**From:** Rylan Phillips <rylan@buildingphillips.com>  
**Sent:** Tuesday, February 3, 2026 2:57 PM  
**To:** Hugo Hamblin-Agosto  
**Subject:** 16040 SW 3rd planning application  
**Attachments:** IMG\_2126.jpeg; IMG\_2128.jpeg

**From:** Rylan Phillips <rylan@buildingphillips.com>  
**Sent:** Thursday, January 8, 2026 8:04:25 PM  
**To:** Hugo Hamblin-Agosto <hamblinagostoh@sherwoodoregon.gov>  
**Subject:** Re: 16040 SW 3rd planning application

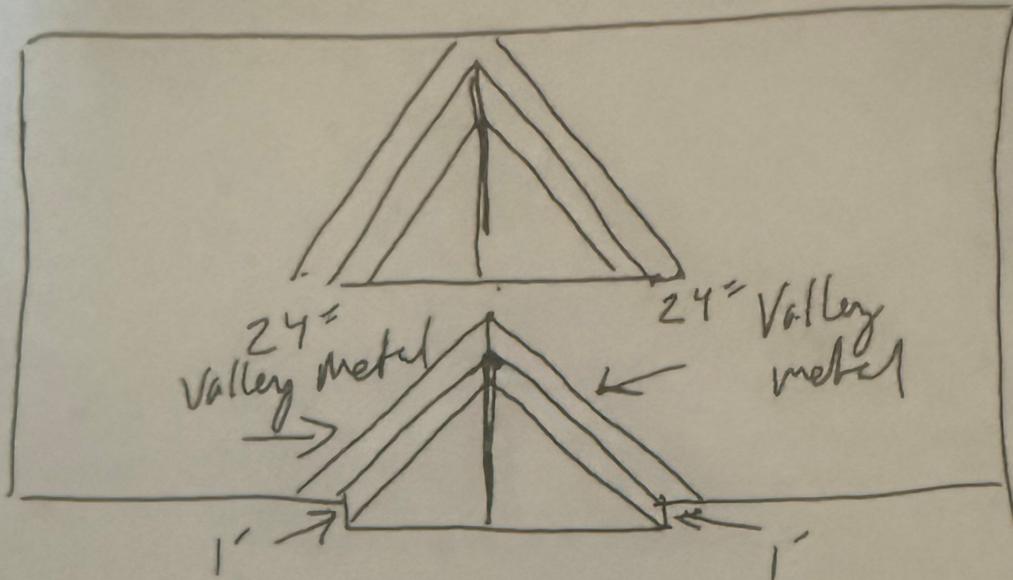
Here is a basic sketch showing why the 1' change in gutter line is needed. Otherwise, water would shoot past the gutter and over the face of the barge rafter.

Front Slope

24" Valley metal to carry water to gutters.
